UNITED STATES
DEPARTMENT OF THE INTERIOR
BUREAU OF LAND MANAGEMENTFORM APPROVED
OMB NO. 1004-0137
Expires: January 31, 2018**SUNDRY NOTICES AND REPORTS ON WELLS**
*Do not use this form for proposals to drill or to re-enter an abandoned well. Use form 3160-3 (APD) for such proposals.*5. Lease Serial No.
NMNM134867

Mewbourne Oil Company has an approved APD for the above well. Mewbourne requests approval of the following variance:

Use of a multi-bowl wellhead. See attached schematic.

**PECOS DISTRICT
DRILLING OPERATIONS
CONDITIONS OF APPROVAL**

13-5/8" MN-DS Wellhead System

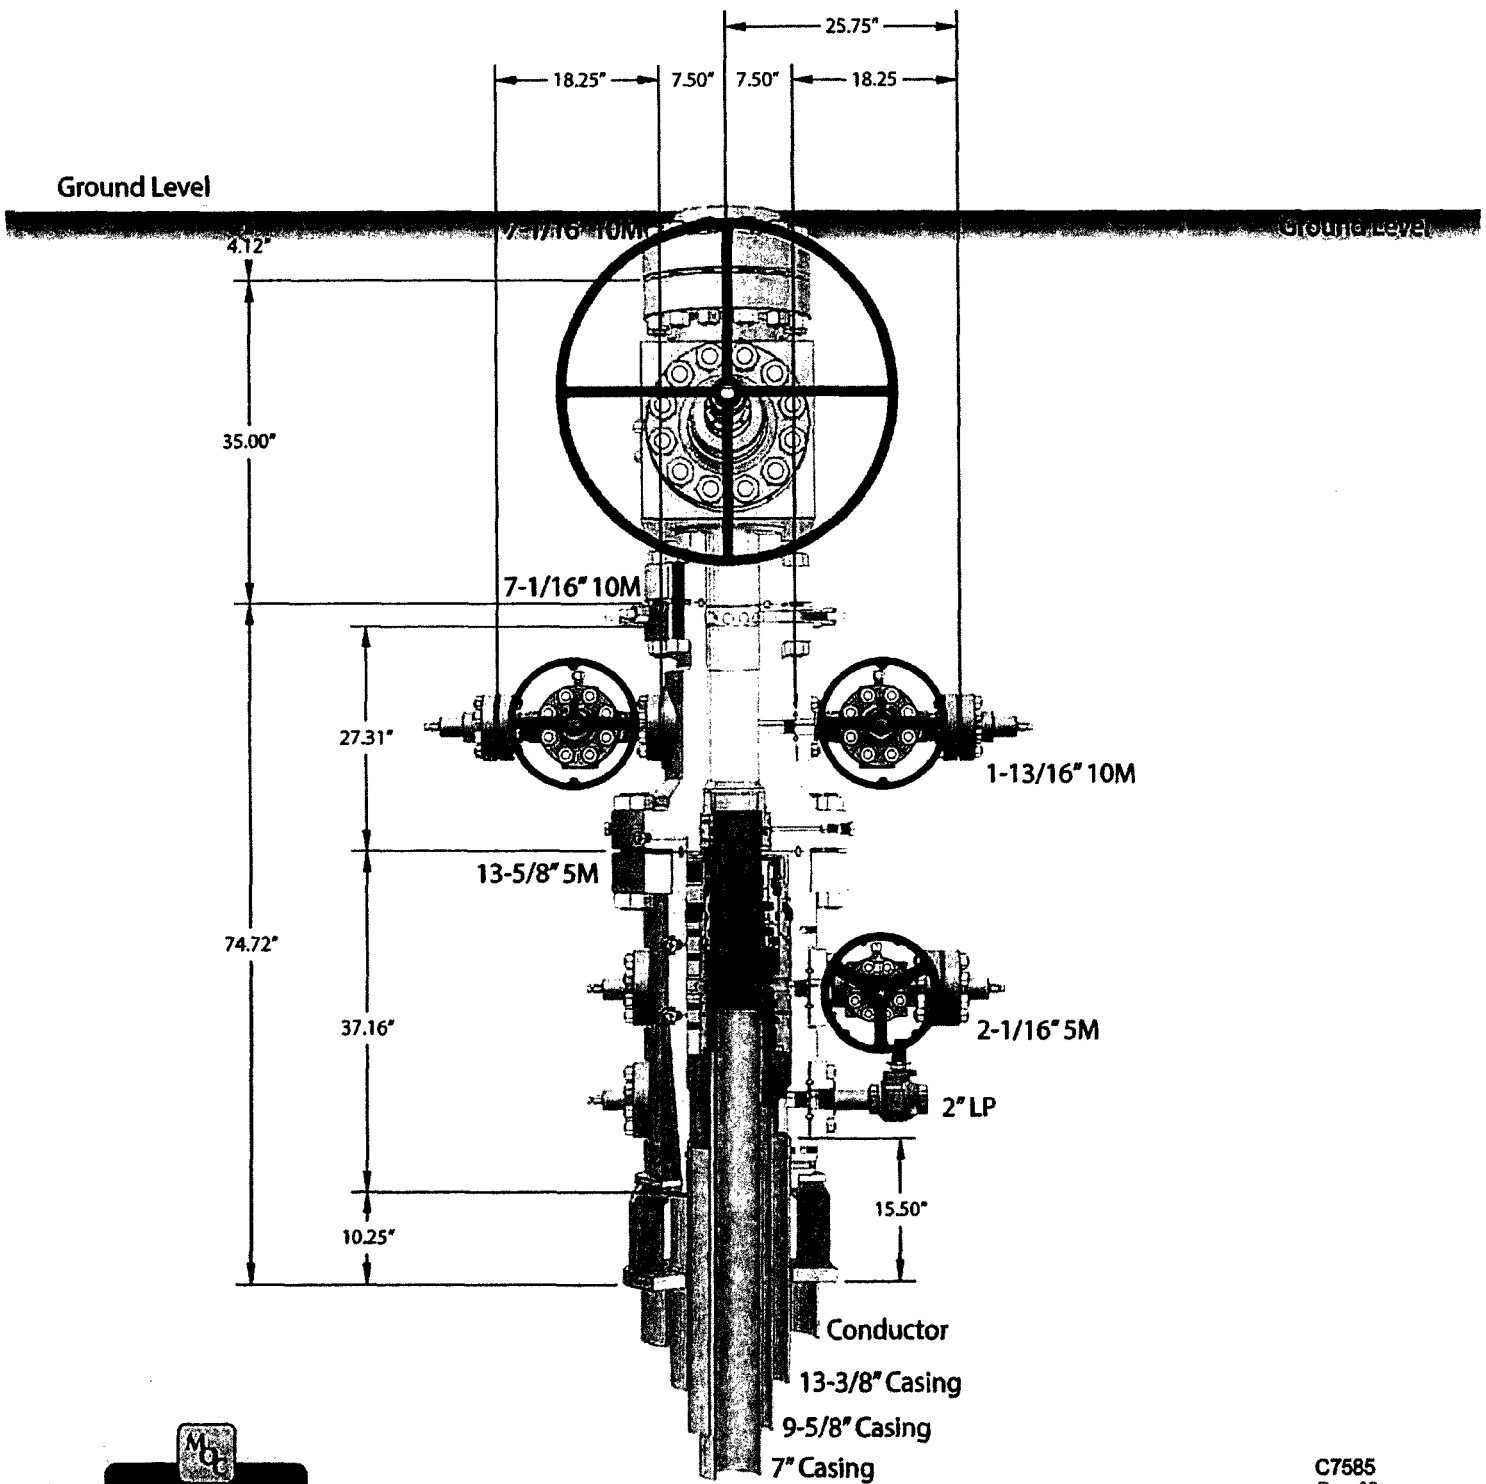
4. **Operator has proposed a multi-bowl wellhead assembly. This assembly will only be tested when installed on the surface casing. Minimum working pressure of the blowout preventer (BOP) and related equipment (BOPE) required for drilling below the surface casing shoe shall be 5000 (5M) psi.**

- a. **Wellhead shall be installed by manufacturer's representatives, submit documentation with subsequent sundry.**
 - b. **If the welding is performed by a third party, the manufacturer's representative shall monitor the temperature to verify that it does not exceed the maximum temperature of the seal.**

- c. **Manufacturer representative shall install the test plug for the initial BOP test.**
 - d. **Operator shall perform the intermediate casing integrity test to 70% of the casing burst. This will test the multi-bowl seals.**

- e. **If the cement does not circulate and one inch operations would have been possible with a standard wellhead, the well head shall be cut off, cementing operations performed and another wellhead installed.**
